**CASE SUMMARY SHEET****CASE NUMBER: V23-07-21****DATE RECEIVED: May 3, 2023****DATE OF MEETING: July 11, 2023 and July 25, 2023****Address: 149 Coffee Street****Subdivision: Old Town of Mandeville, Square 26 Lot Z****Zoning District: R-1 Single Family Residential District****Property Owner: Luci and Josh Brandner**

**REQUEST: V23-07-21 – Luci and Josh Brandner request a variance to CLURO Section 5.2.3.2. Drainage Overlay District and Fill Sub-Area A, Old Town of Mandeville, Square 26 Lot Z, R-1 Single Family Residential District, 149 Coffee Street**

1 SITE PLAN WITH EXISTING TREE DRIPLINES  
 A3.8 1/16" = 1'-0"

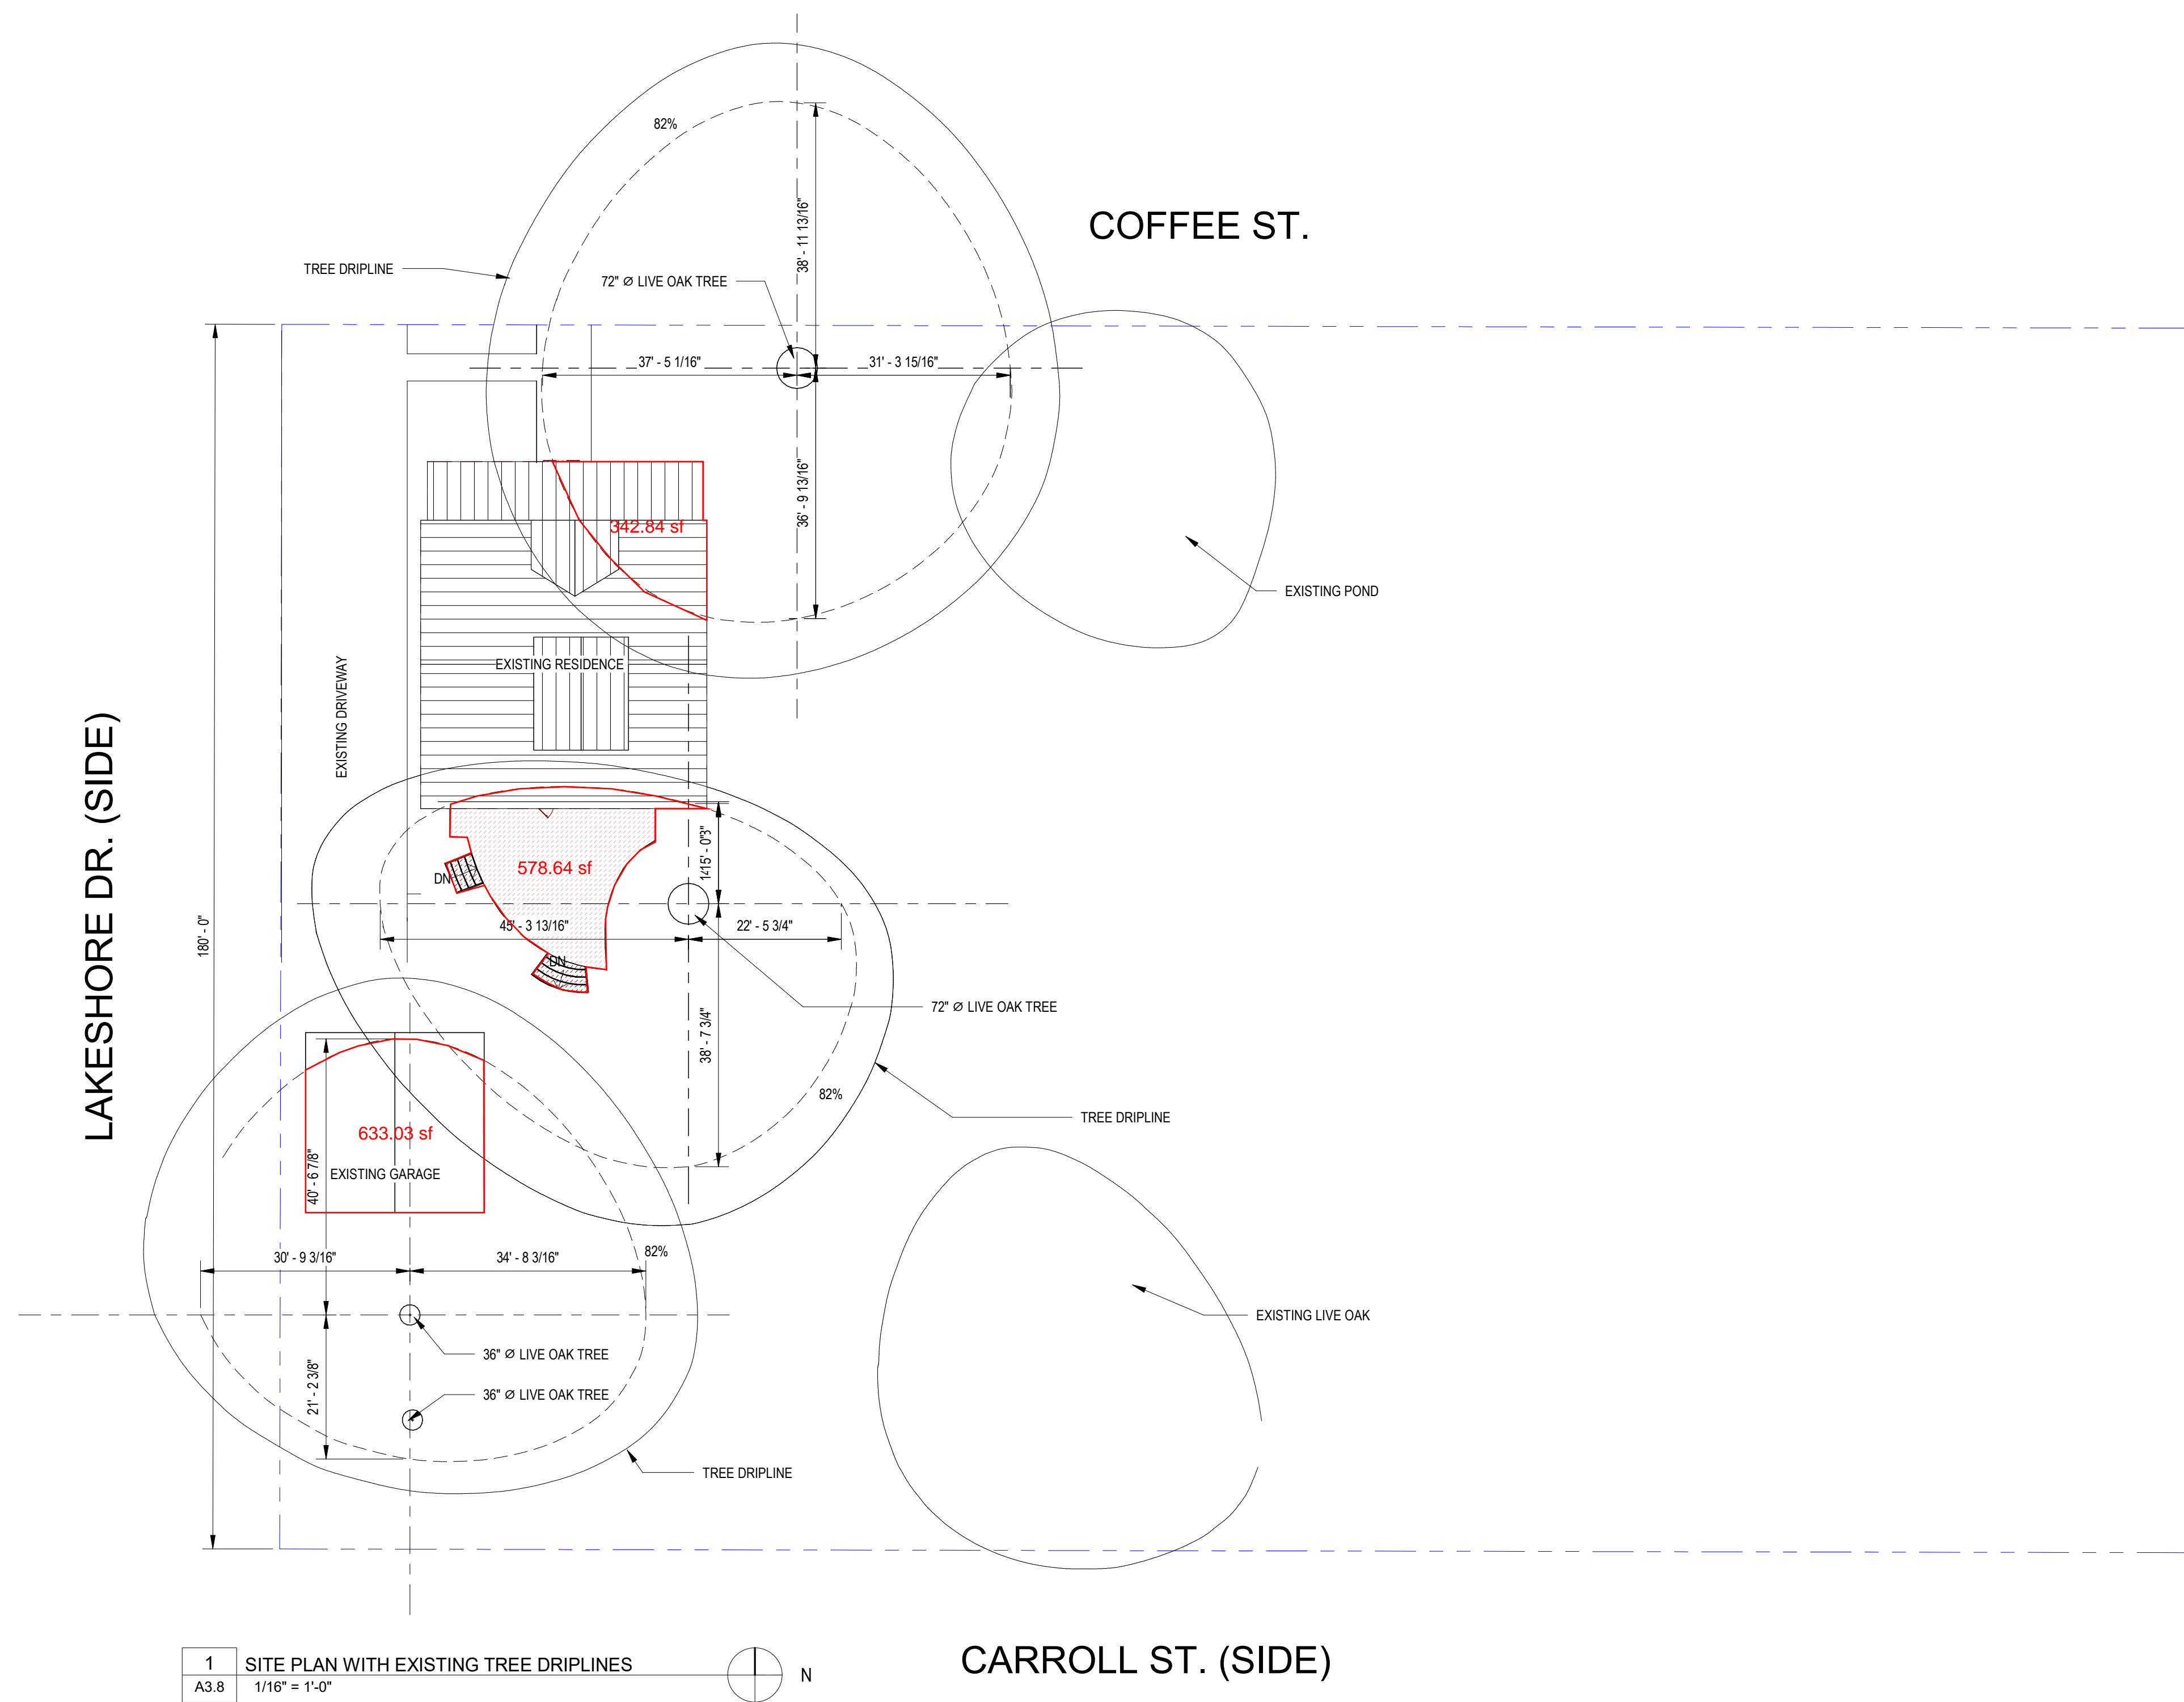
Public Works had the following comments: The bottom slab heights were originally designed and compliant with our regulations using a stepped design. The slab was to be formed using 4 levels because of the existing grades ranging from 3.1 – 5.2 ft. The USACE as determined the footprint of the addition not to be in wetlands and STP Local Coastal Program Manager has reviewed stating the proposed is Exempt from a Coastal Use Permit. The one exception noted by the STP CPM is that no fill is to be placed outside of the footprint of the structure.

The lot is within the City's Drainage overlay district and the proposed structure is in an area of periodic inundation (CLURO 7.6.1.3). These requirements would apply except for the foundation height standard of Section 5.2.3.2. Drainage Overlay District and Fill Sub-Area A.

# RESIDENTIAL LOT DRAINAGE PLAN JEFFERSON STREET (SIDE)

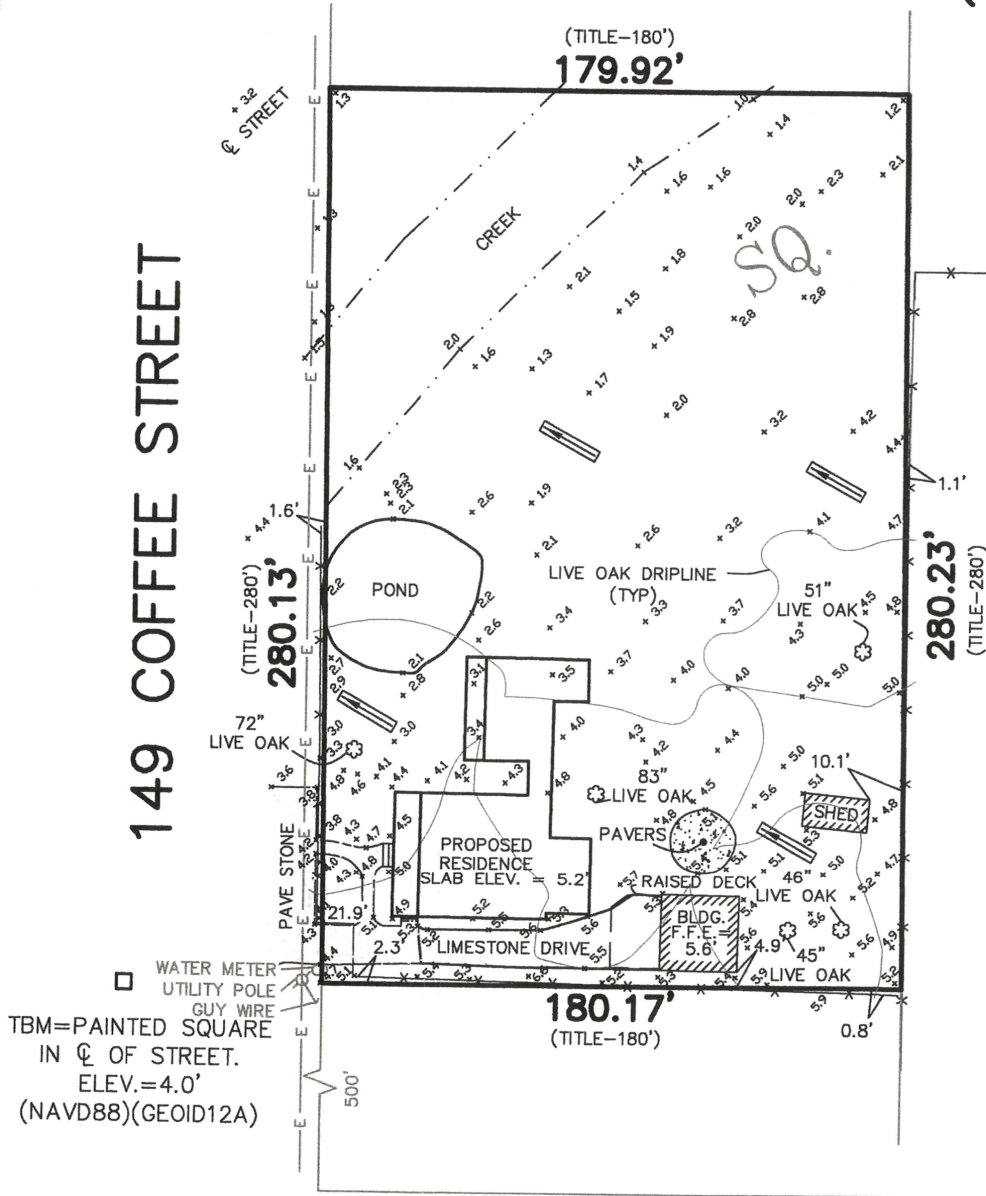
The bottom slab heights were originally designed and compliant with our regulations using a stepped design. The slab was to be formed using 4 levels because of the existing grades ranging from 3.1 – 5.2 ft. The USACE as determined the footprint of the addition not to be in wetlands and STP Local Coastal Program Manager has reviewed stating the proposed is Exempt from a Coastal Use Permit. The one exception noted by the STP CPM is that no fill is to be placed outside of the footprint of the structure.

The lot is within the City's Drainage overlay district and the proposed structure is in an area of periodic inundation (CLURO 7.6.1.3). These requirements would apply except for the foundation height standard of Section 5.2.3.2. Drainage Overlay District and Fill Sub-Area A.
